Sujet: Capteur p0t0 (904613138A)

Subject: p0t0 sensor (904613138A)

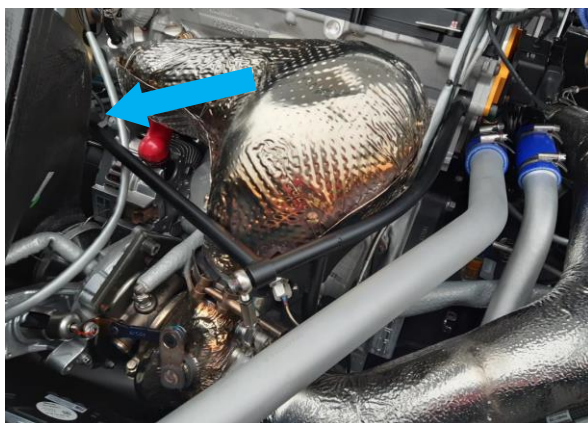
Sur les moteurs équipés de la suspente turbo 904631268E (cf photo de gauche ci-dessous), merci de vérifier la proximité entre le capteur p0t0 (sur la boîte à air) et la suspente turbo au niveau de l'alternateur.

On the engine equipped with the turbo holder 904631268E (see left picture below), please check the proximity between the p0t0 sensor (fitted at the back of the airbox) and the turbo holder close to the alternator.

Afin d'éviter d'endommager le capteur, nous vous recommandons de protéger la suspente (par exemple avec un rilsan étiquette).

In order to preserve the sensor, we recommend you to protect the holder (by example with a label ty rap).
